# REDTAIL RANCH PRELIMINARY PLAN

A PORTION OF THE NW1/4 OF SECTION 9, TOWNSHIP 12 SOUTH,  
RANGE 65 WEST OF THE 6TH P.M. AND LOT 1 WALKER PLACE  
COUNTY OF EL PASO, STATE OF COLORADO

DATE: 7/03/2018 BY: MS DESCRIPTION: INITIAL COUNTY SUBMITTAL

PRELIMINARY PLAN

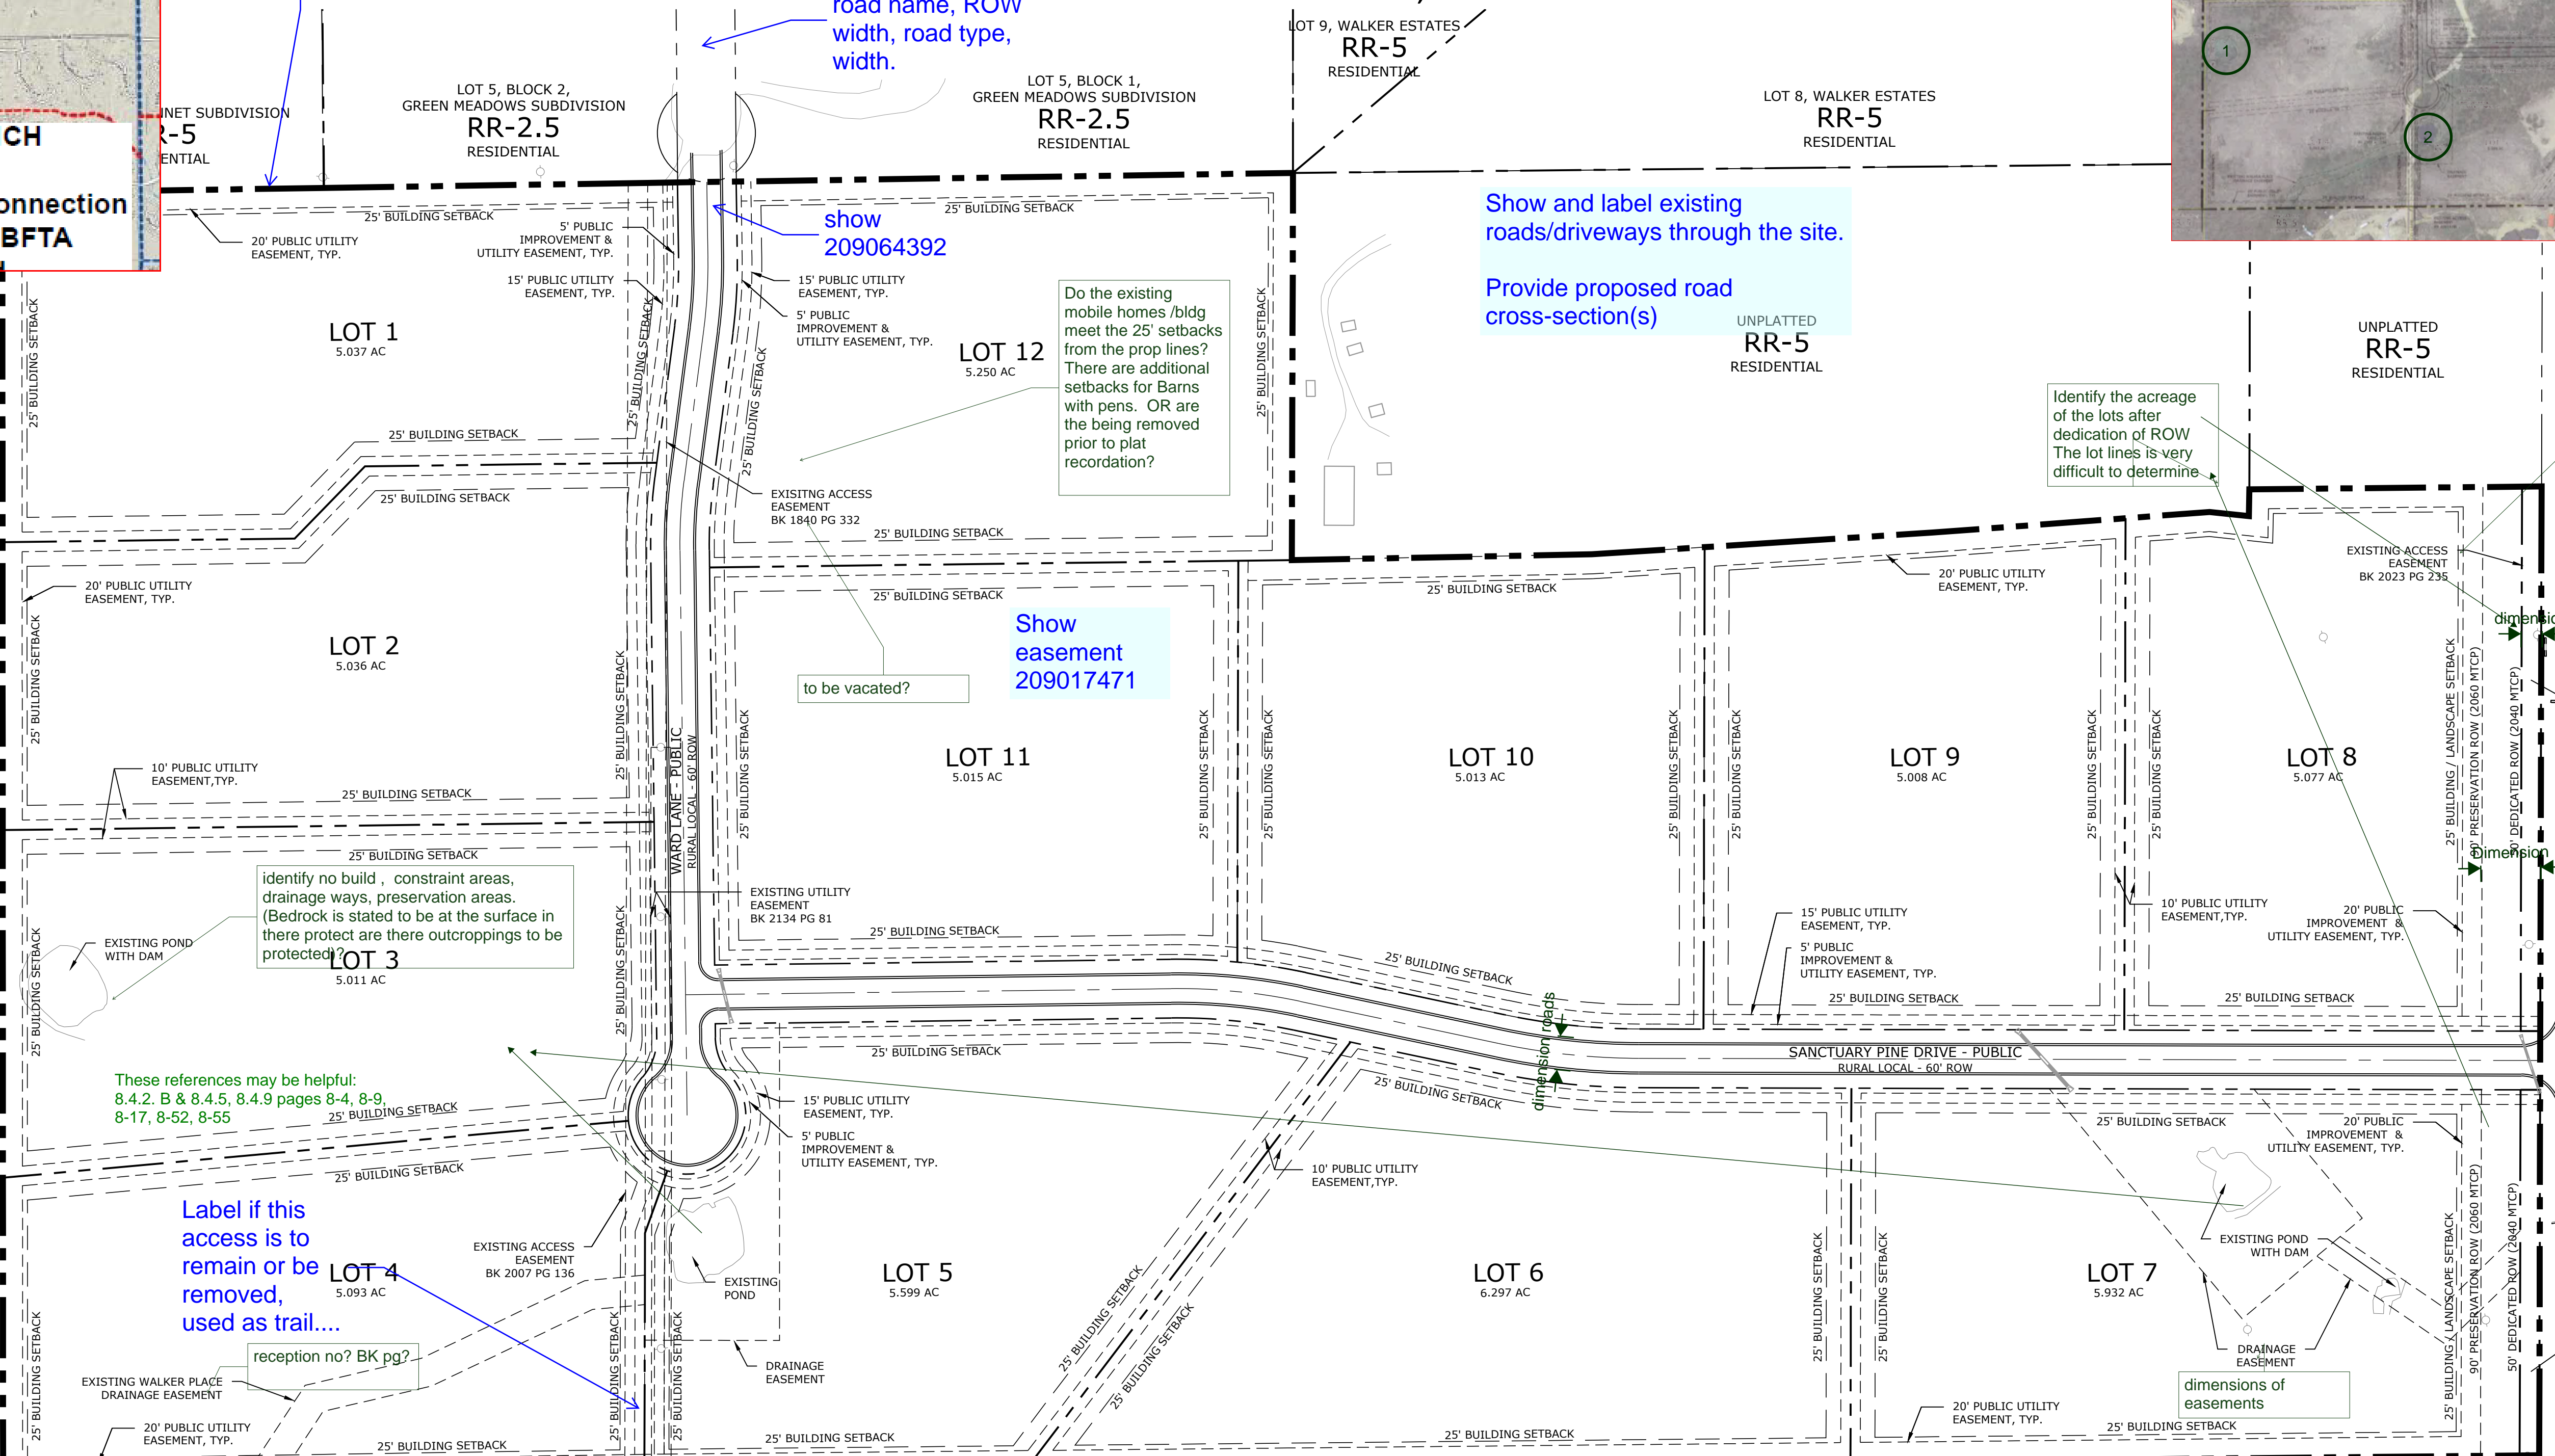
There are existing ponds and drainage ways that should be in easements if they are to remain and no build areas, no septic areas.

How is this consistent if trails shown in BFLUP are not depicted?

Label exterior boundary bearings and distances.

Vacation of lots 1-4 etc.....

Label as existing, road name, ROW width, road type, width.

Show and label existing roads/driveways through the site. Provide proposed road cross-section(s)

Do the existing mobile homes /bldg meet the 25' setbacks from the prop lines? There are additional setbacks for Barns with pens. OR are the being removed prior to plat recording?

Identify the acreage of the lots after dedication of ROW. The lot lines is very difficult to determine.

Label the necessary improvements to Vollmer Road including widening and shoulders to provide adequate access.

clarify linework and type for lots, tracts, easements

to be vacated?

identify no build, constraint areas, drainage ways, preservation areas. (Bedrock is stated to be at the surface in there protect are there outcroppings to be protected)

Label if this access is to remain or be removed, used as trail....

Label as existing, ROW width, road surfacing, width.

Your missing many of the required preliminary map items: contours, name and address of adjoining prop owners, street centerlines, radii of curves, dimensions of each lot (not angles), trail connections, widths of watercourses (drainage ways) culverts, and identify them, notes to indicate maintenance responsibilities of drainage ways and ponds, length width and location of proposed and existing easements, approx fees in lieu of land to be paid, constraints or hazards to be mitigated or avoided, natural features (if any surface bedrock outcroppings) map

- Approval of replat will vacate all easements by a separate instrument or document. **DELETE note this is not a plat**
  - All existing buildings to be removed.

Correct legal.

Add not e referencing Wieland fire

Add Geologic Hazard/Constraint Note-t: (to be customized based upon the individual circumstances)
